To: X3T10 Membership  
From: Dean Wallace  
Subject: SCSI Single Ended Termination  
Date: 11/4/96

X3T10/96-245

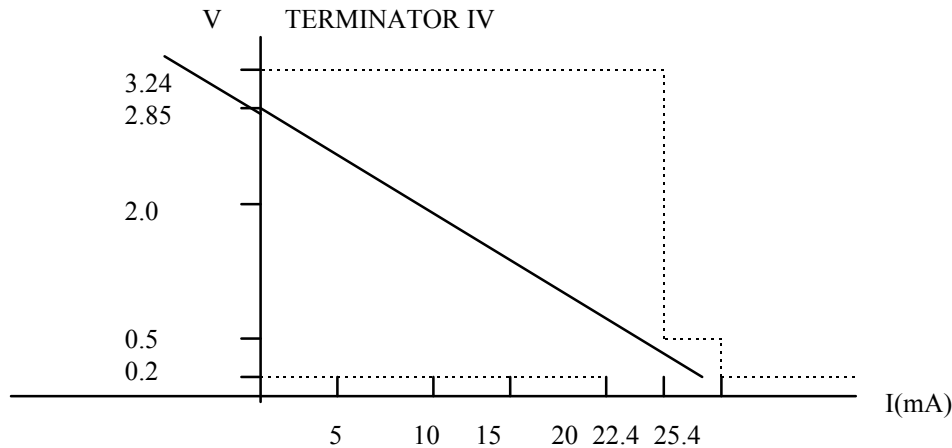
The SCSI-2 alt-2 terminator and the SPI alt-2 terminator can be incompatible. The SCSI-2 alt-2 terminator (the 220/330 was still allowed) was allowed to source 22.4mA (@0.5V) and the current at the driver could not exceed 48mA (@0.5V). The SPI document allows a maximum terminator current of 24mA (@0.2V). Therefore the SCSI-2 terminator is not compatible with the SCSI-3 SPI terminator. The 2.85V, 110 ohm alt-2 terminator exceeds 24mA (@0.2V). For the alt-2 terminator using 22.4mA max at 0.5V and the SCSI-2 minimum impedance of 100 ohms the maximum allowed current at 0.2V is 25.4mA.

The proposal for the termination IV characteristic is:

- The terminator maximum dc current at 0.2V is 25.4mA. The terminator maximum dc current at 0.5V is 22.4mA.
- A minimum dc current of 20mA at 0.2V is also specified. (This isn't changing anything since the maximum alt-2 impedance of 132 ohms is approximately this value).
- The terminator should not source current whenever the terminal voltage is greater than 3.24V.
- The terminator shall source current to the line when the terminal voltage is below 2.5V dc.
- The terminator open circuit voltage should be at least 2.5V.

The IV chart shows the allowed operation area for the single ended terminator. Anything outside the dotted lines is not allowed. The region below 0.2V was left open for undershoot clamps and the sink current region (left of center axis) is open because minimum and maximum sink currents are not specified. I think the above wording along with the chart specifies the terminator without having to specify an output impedance. The solid line in the middle of the chart is the ideal alt-2 terminator (for reference). If an impedance range of 100 ohms to 132 ohms is specified then we need to explain what the alt-2 terminator is. Also specifying a minimum current of 20mA at 0.2V (with a minimum  $V_{term}$  of 4.25V gives 17.8mA) removes the 220/330 terminator without having to specifically call it out. Finally reducing the terminator (enabled) output capacitance from 25pF to 12.5pF should be done. Probably of more importance would be a maximum disabled output capacitance.
